3. CASE 20.043, 150 LLOYD AVENUE, J. W. Tillinghast House, post1903 (COLLEGE HILL)

**Applicant/Owner:** 150 Lloyd LLC, 4 Woodland Terrace, Providence, RI 02906

**Proposal:** The scope of work proposed consists of Major Alterations and includes:

- The applicant is the replacement of the existing slate roof with an architectural shingle roof and the installation of an ADA-accessible ramp to the side (west) porch.

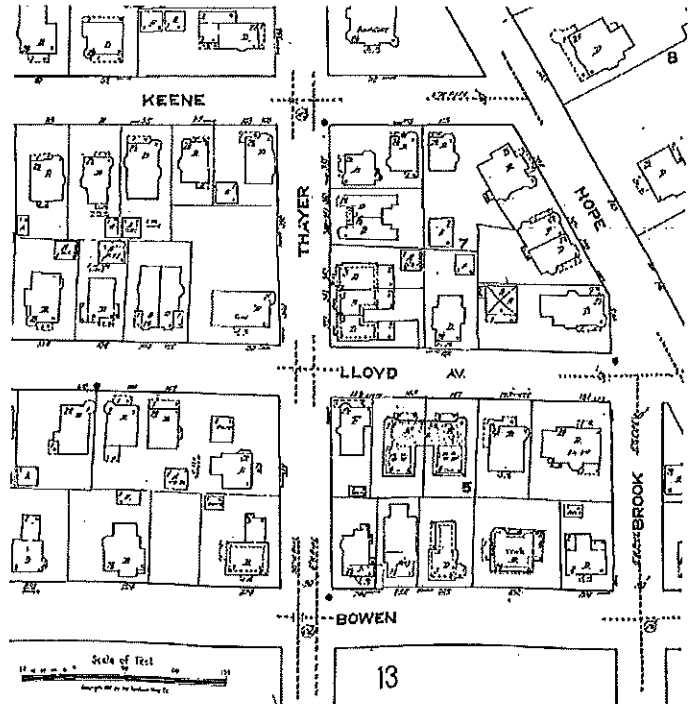
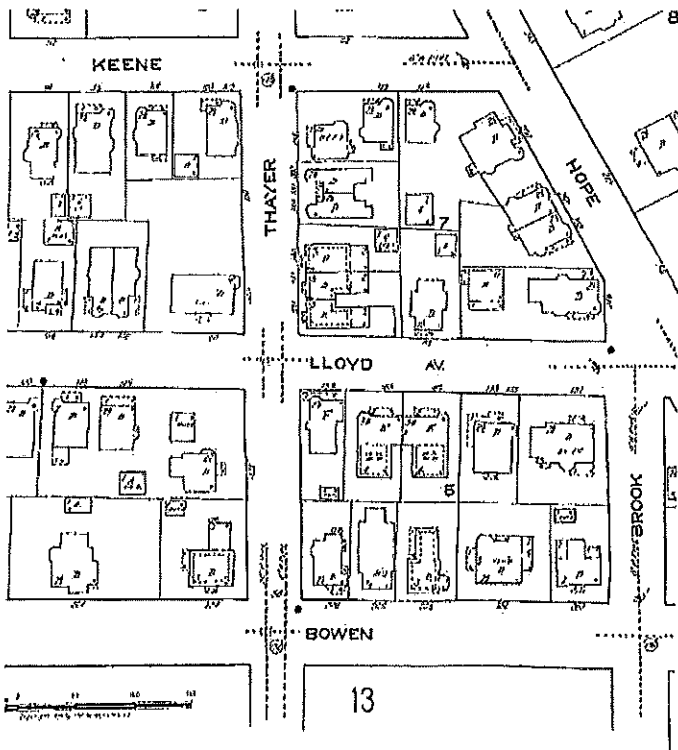
- The west side porch does not appear on any Sanborn maps up to 1956. The National Register description states that this porch was a later addition. There is an existing curb-cut and parking space adjacent to the area on Lloyd Ave, which will be used for handicap-accessible parking. The existing entry will not be modified in the proposal. The proposal meets the Standards in that it is in an innocuous location, being added on to a later addition to the building.
- Drawings and estimates have been submitted.
